**RE: Review of Submission  
Visual Arts Center (VAC)  
1632 West Chester Pike  
West Chester, PA 19382  
(Westtown Township)**

As requested, we have performed a review of plans and concept images for the Proposed New Building at 1632 West Chester Pike, that will accommodate a New Visual Arts Center. Materials that were provided to us are:

# WEST CHESTER PIKE (S.R. 0003)

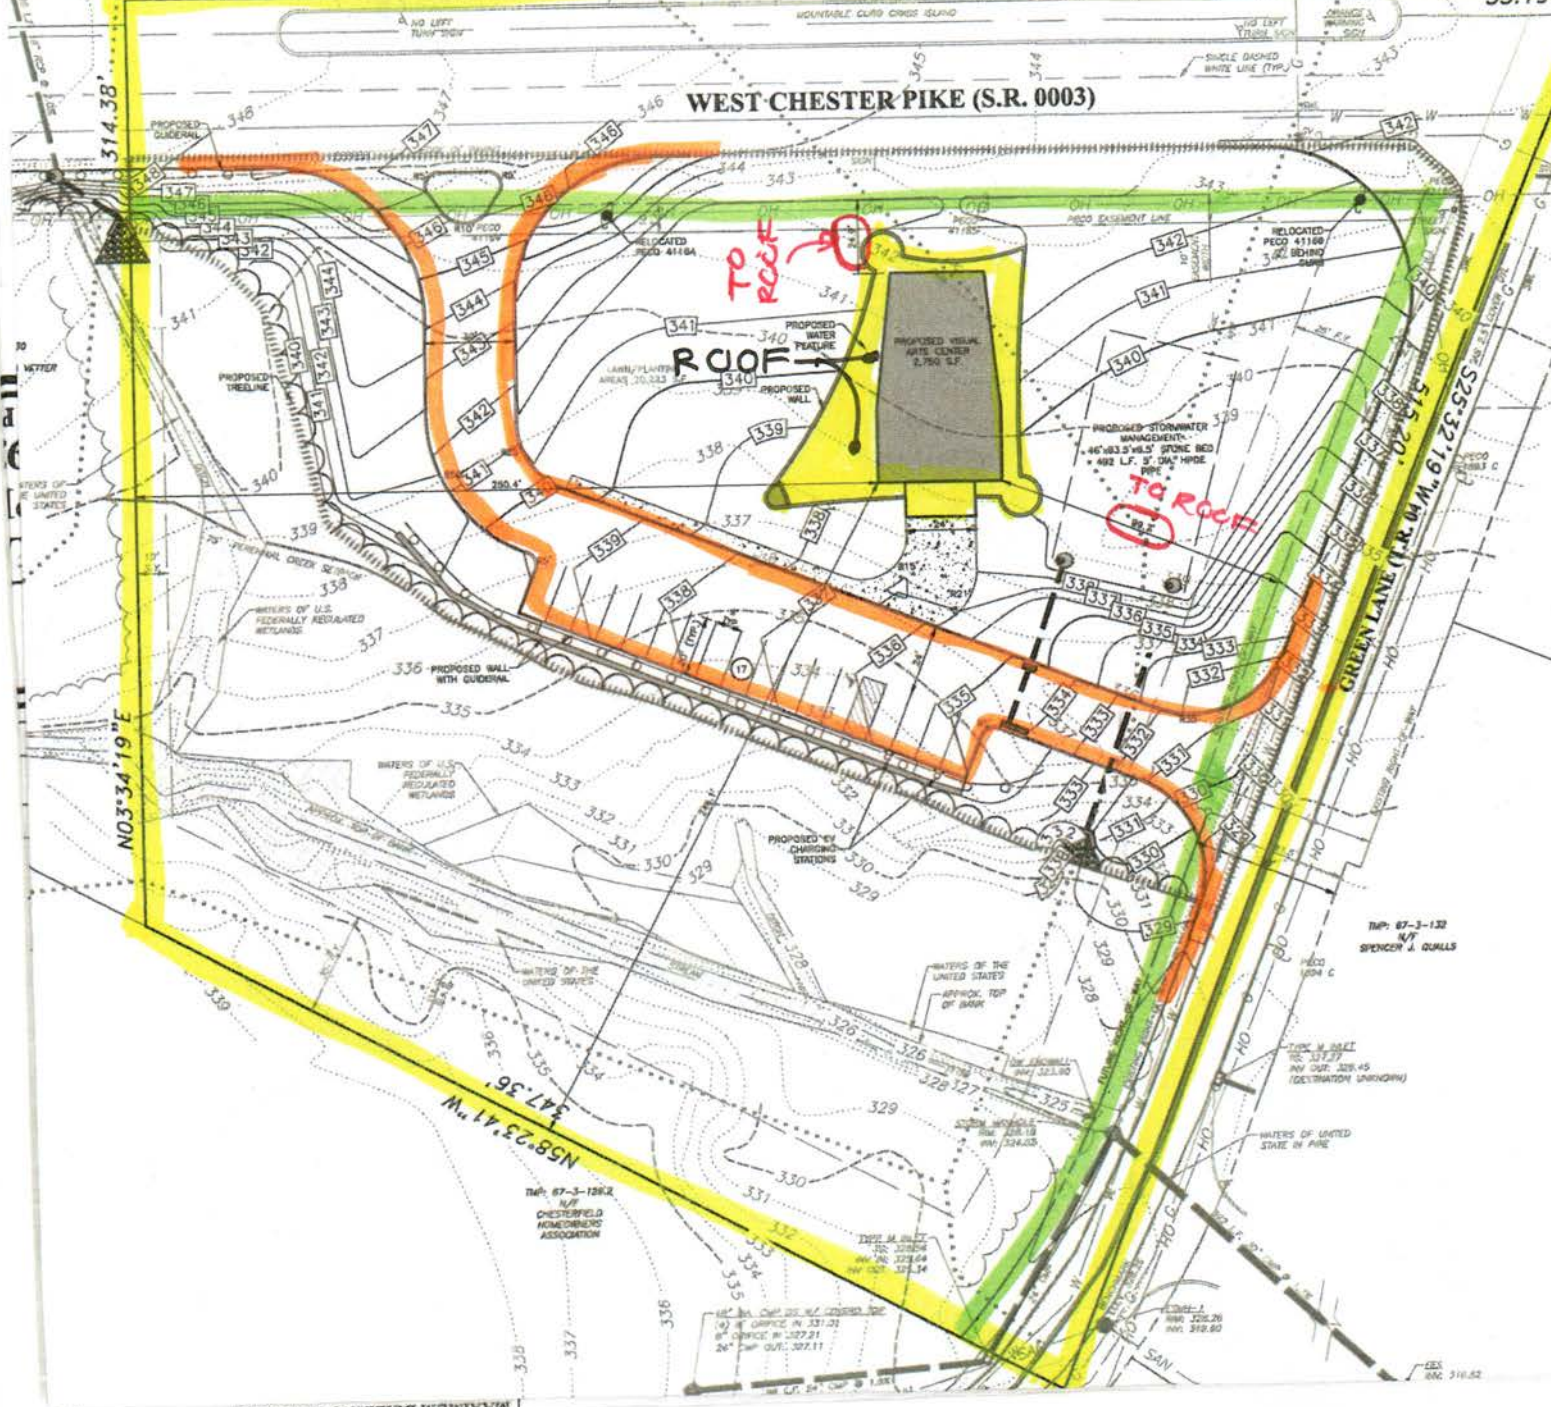
- All other zoning information in the zoning block appears to be compliant.
- 5) The plans show all development will occur with a 75-foot setback to the top of bank of the perennial stream. Although not dimensioned on the plan, the parking lot development line is approximately 45 feet from the wetlands at the closest point. I will defer to the Township Engineer on compliance of these two (2) dimensions.

## ZONING: R-3 RESIDENCE-OFFICE DISTRICT

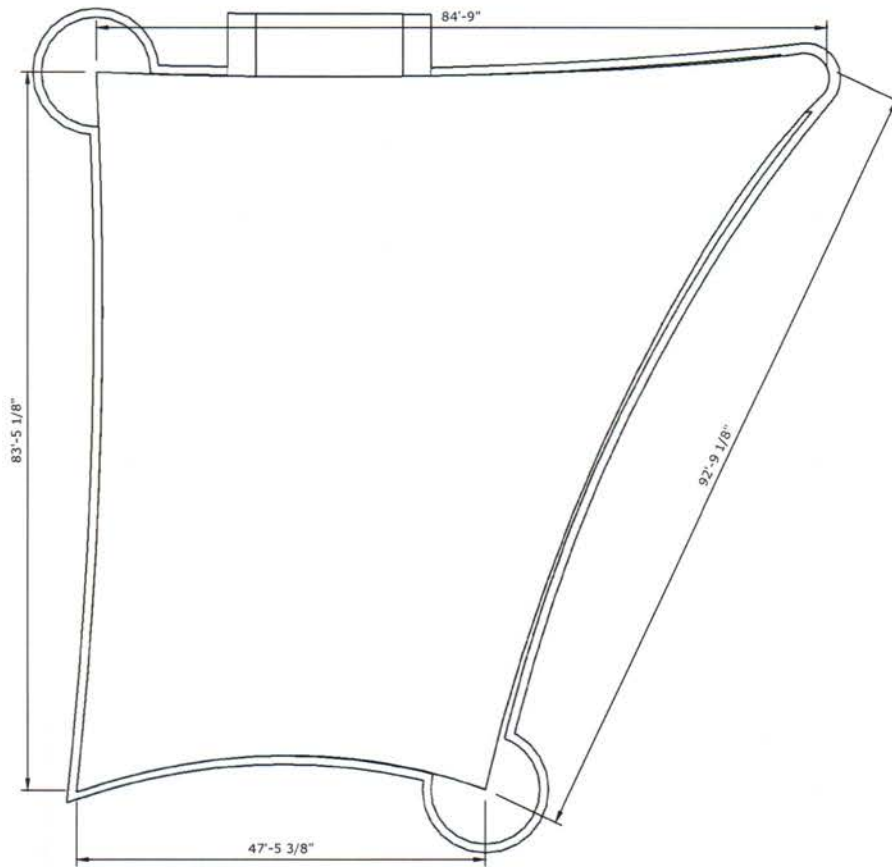
- 3) 170-802G has a 2 Page list of requirements for a Visual Arts Center.
- 4) From a dimensional standpoint, the zoning compliance block on Sheet 1 of the Inland Design drawings, shows the lot size, setbacks, building coverage and impervious coverage for a Visual Arts Center.

- A second front yard setback line needs to be added, since this corner property has 2 front yards.
  - On the plan the dimension of the front yard setback is dimensioned to the building wall, and not the roof element, has a significant overhang. The dimension need to be instead listed to the roof for both yards.

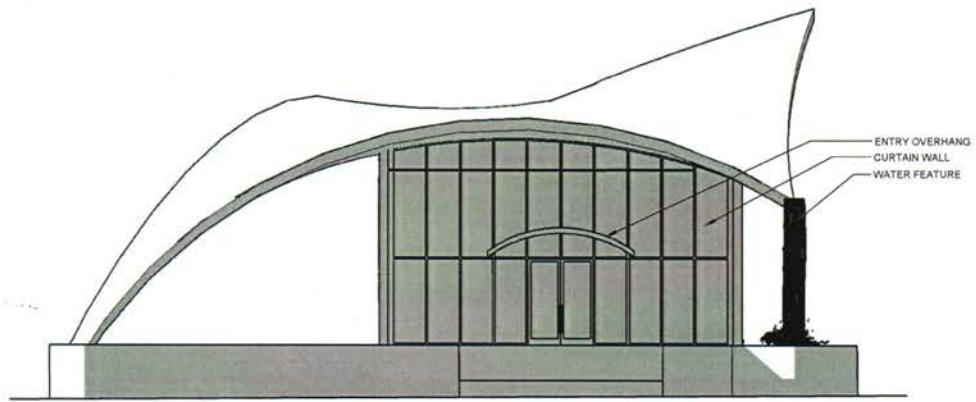
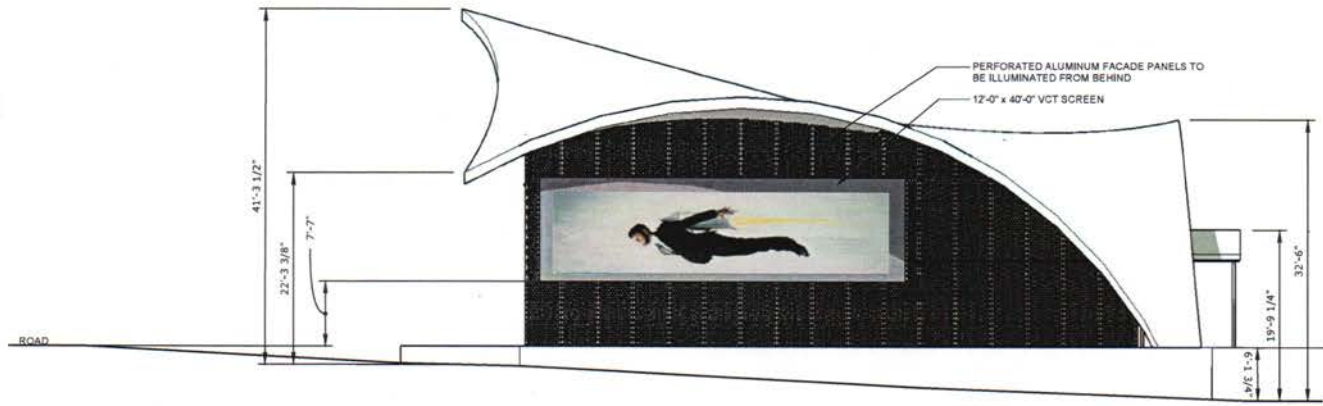
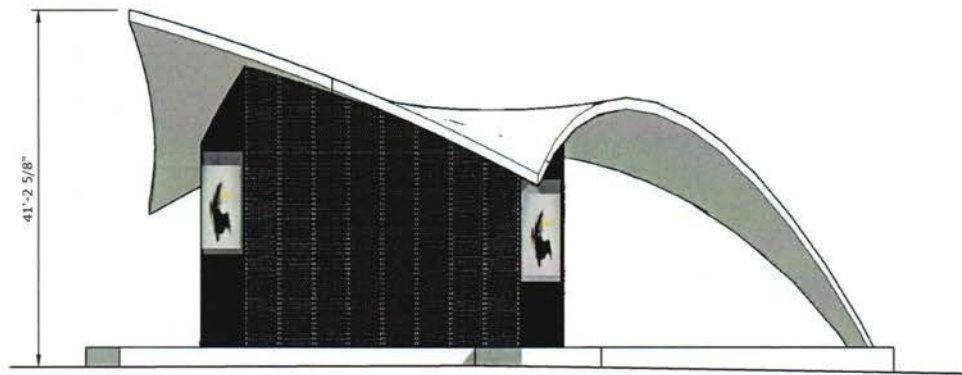
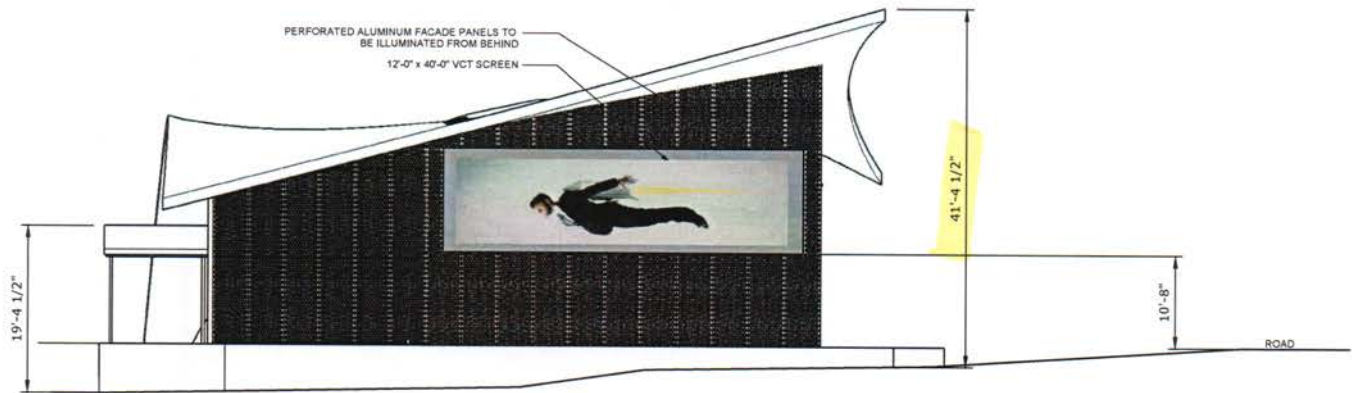
- 1) The site plans indicate a proposed 2,750 s.f. building, with a "water feature" surrounding the building.
- 2) When I look at the concept images that were provided, this "water feature" also seems to be approximately the same shape as the decorative roof above the building. This roof has an approximate area of 5,500 square feet, so it has twice the footprint size of the building below.
- 3) The concept plans indicate the undulating roof will be 32'-6" high at the low point, and 41'-4" high at the high point.

The maximum building height allowed is "four stories", and since a story is often considered to be 10 feet in our industry, this minor deviation needs to be discussed, to see how 4-stories is being interpreted.

- 1) In addition to the architectural statement made by the roof design, the buildings' exterior walls also make a visual statement. The walls on the east, north, and west consist of perforated aluminum panels, with glass behind them, allowing the interior lighting to shine through the perforated panels. (I believe all the elevation drawings are mislabeled, with north and south being reversed, as well as east and west also being reversed). Since the perforated panel facades all face adjacent commercial buildings or West Chester Pike, I don't anticipate the light being projected through the holes being a problem, but no different than for a site light fixture, a photometric showing a foot-candles should be performed.

- 2) The greater concern I have is the at the 25-foot-high glass curtain wall and main entrance face south toward the rear of the townhouses, so a prediction of light spill through that façade wall, and to the south should be provided.
